Design Advice Request

SUMMARY MEMO

Re: EA 22-123934 DA – 61 Unit Housing Development

Design Advice Request Summary Memo July 7, 2022

GROUND FLOOR PLAN LEVEL 1

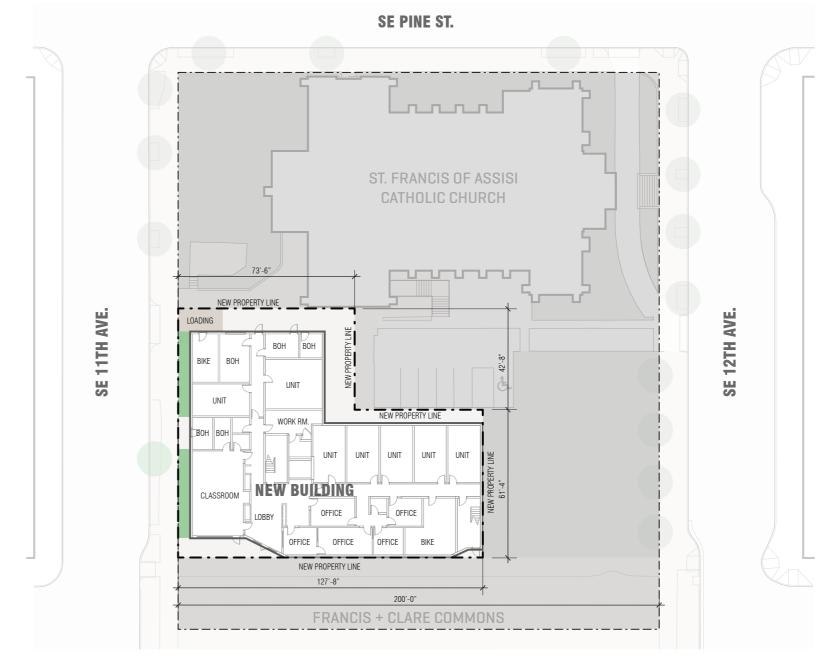
- Commission agreed the ground floor program included too much back-of-house use along SE 11th Ave and too little activation along both of the primary elevations: west and south.

- 4. Main Entries:
- 5. Building Frontages and Activation;
- 6. Modifications.
- Commissioners supported a stronger corner (SE 11th and vacated SE Oak St.) design than what was presented.

- Commissioners agreed the entrance should not be recessed but rather should be pulled out to the corner (SE 11th and vacated SE Oak St.) to provide increased visibility, access, and prominence.

- Commissioners agreed the proposed loading was not well located and well utilized.
- Commissioners agreed the proposed Modification to *Transit Street Main Entrances* (33.140.242.C.3) to allow for a recessed entrance, is not approvable.

6. Modifications:

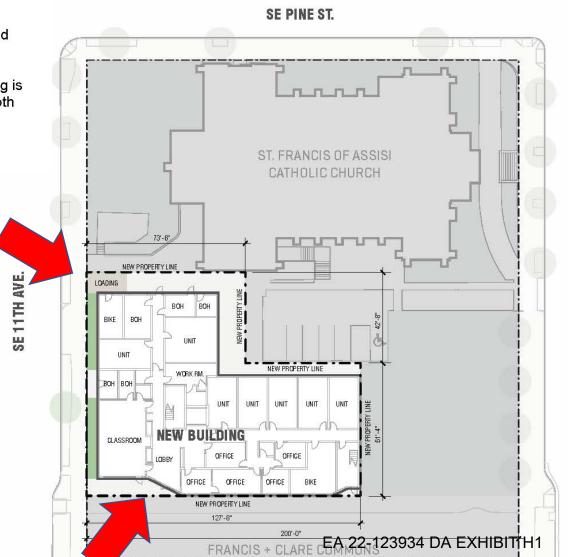
- The proposed development requires four Modifications:
 - a. Vehicle Access (from SE 11th Ave): 33.510.263:
 SE 11th Ave is a "Major Truck Street" which does not allow access to parking or loading. The proposal includes access to loading from SE 11th Ave.
 - b. <u>Transit Street Main Entrances: 33.140.242.C.3</u>:
 The main entrance must be within the 10-foot maximum setback. The proposed main entrance is setback approximately 35 feet into the site.
 - c. <u>Landscaping: 33.266.310.E</u>: Loading must comply with the setback and landscaping requirements of either 5 ft. / L2 or 10 ft. / L1. The proposed loading is at the property line with no landscaping. This would require Modifications to both the setback and the landscaping requirement of this standard.
- Staff requests comments on the potential approvability of the proposed Modifications.
